RECORD OF DECISION

**BOOMSNUB/AIRCO SUPERFUND SITE
HAZEL DELL, WASHINGTON**

February 2000

**Boomsnub/Airco Superfund Site
Record of Decision**

Figure 5-7
Trichloroethene Concentrations (ppb) in the Alluvial Aquifer
May 1998

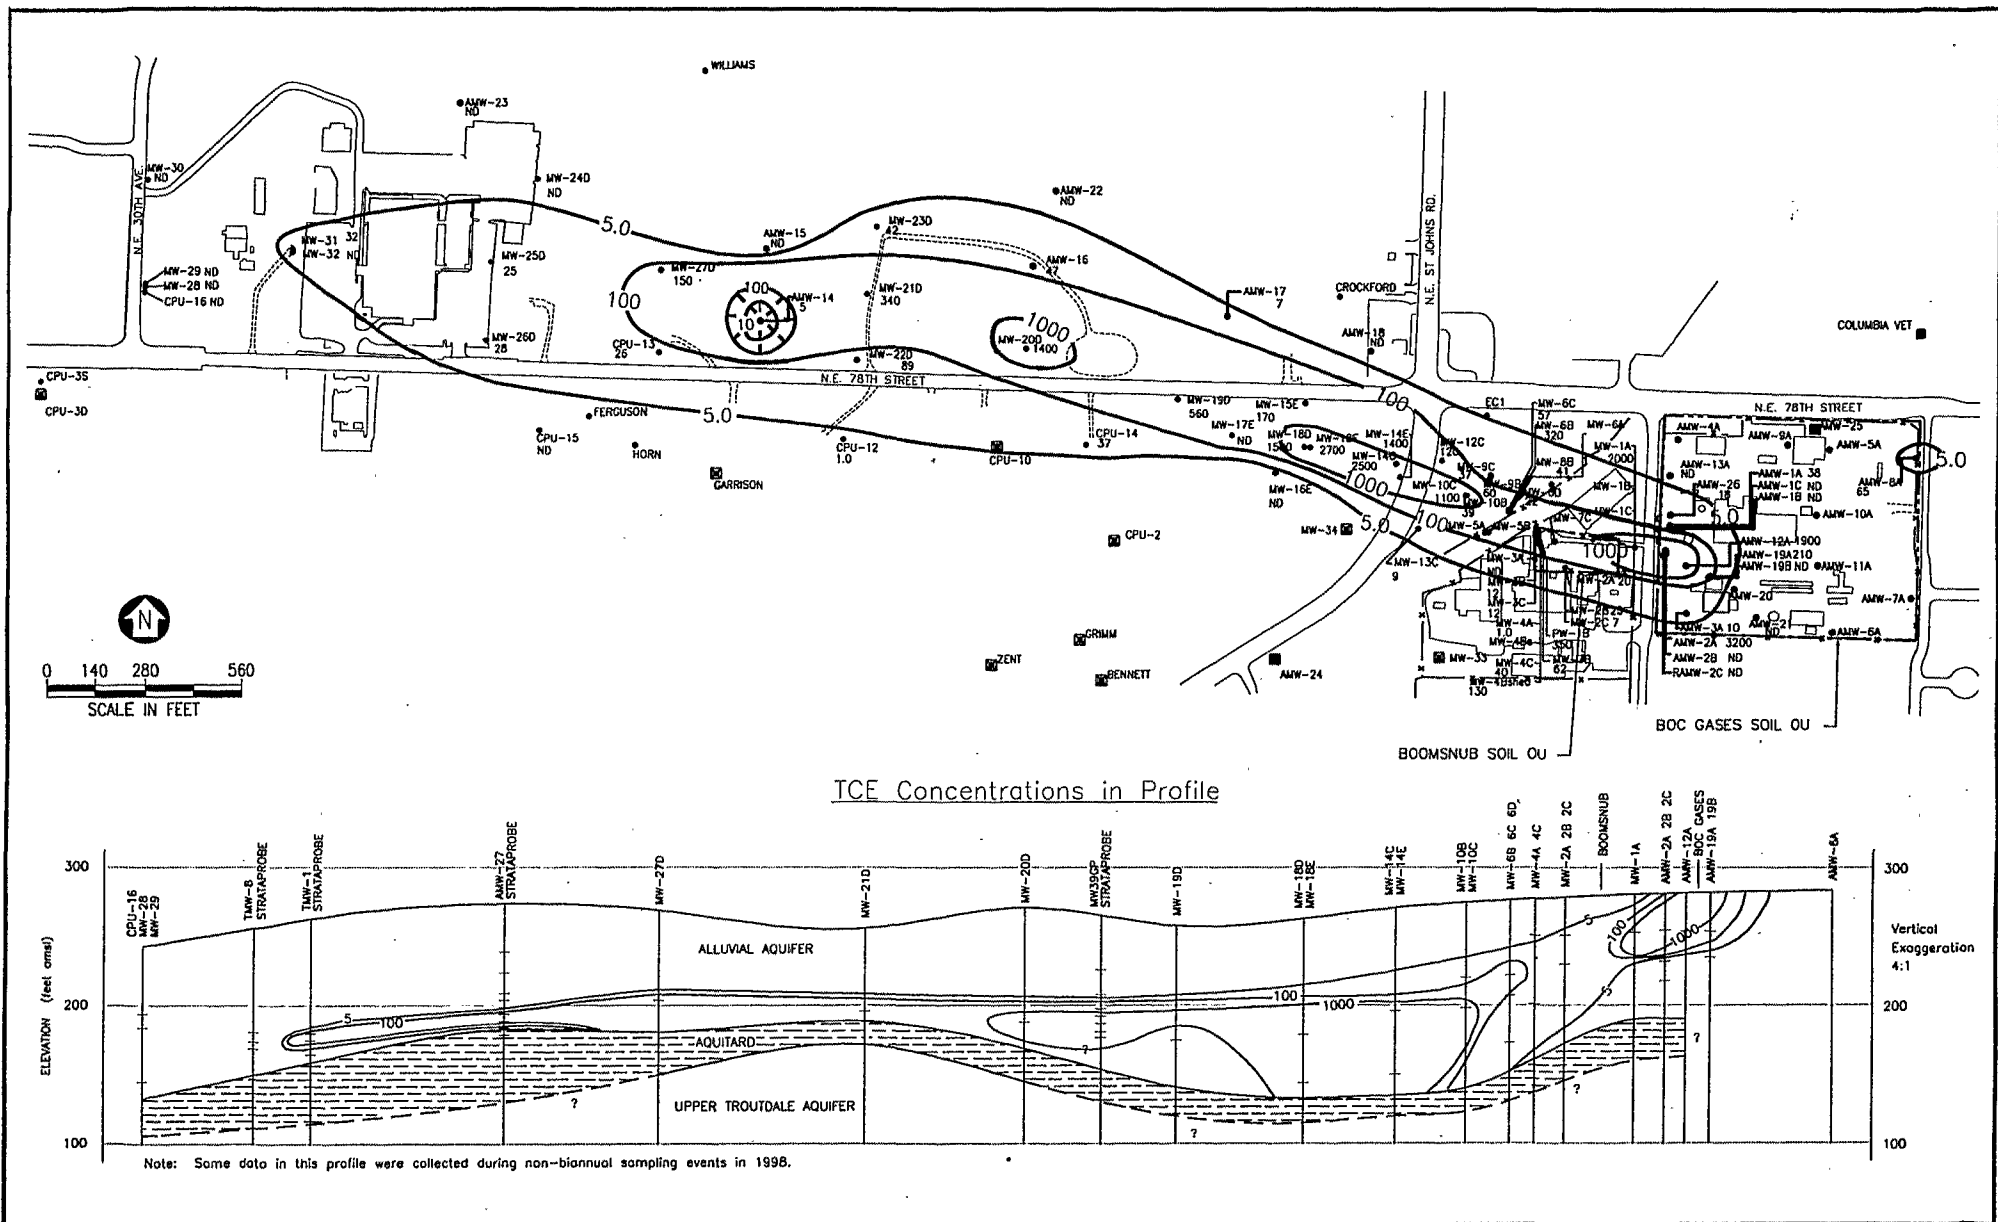
Comment: Page 3, Figure 1: The concentration contour for the cleanup standard is listed as the MTCA Method B Cleanup Standard (3.98 ug/L) is different than page 5 under Summary of Preliminary Remediation Goals, where the preliminary remediation goal for TCE is listed as 6 parts per billion and the MCL. BOC requests clarification on which cleanup standard applies.

Response: EPA has clarified in this ROD that the applicable cleanup standard for TCE is the federal MCL of 5 ppb. This clarification is reflected in Figures 5-5 and 5-7 of this ROD, and in Table 7-2. As shown in Table 7-2 of the ROD, the MCL is the cleanup standard unless the risk
